SERVICE BULLETIN**Affected Equipment:** YCAV & YCIV AIR COOLED CHILLERS**Subject:** Discharge Temperature Sensor Leaks**Issue Date:** 1/24/12**Withdrawal Date:** 1/2/14**Data Control Level:** x**Materials Needed:** 025-32924-000 Discharge Temperature Sensor, one per circuit.**Tools Required:** As needed to replace a defective sensor. This includes general tools of the trade, vacuum pump and a refrigerant cylinder for storing R-134a.**Estimated Time Required:** 4 hours per sensor replacement.**Warranty:** See details within the bulletin.**PROBLEM**

**FIGURE 1 - DISCHARGE TEMP SENSOR COMPRESSOR LOCATION**

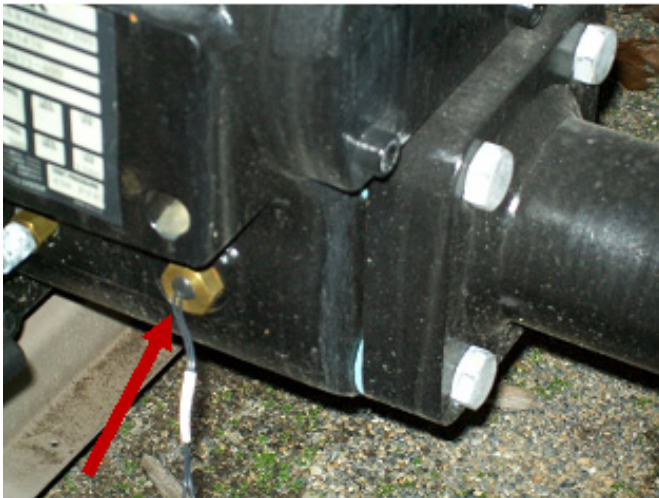
Long body discharge temperature sensors (025-43945-000) threaded into the discharge housing of MTS compressors may fail due to a machining problem that causes the brass sensor body to crack after ongoing exposure to the discharge gas stream in the compressor. When a crack occurs, the sensor will leak refrigerant into the crack in the brass tube exposed to the gas stream and out through the external sensor wiring. The location of the sensor and an example of the long body sensor is shown in *Figures 1* and *2* below.
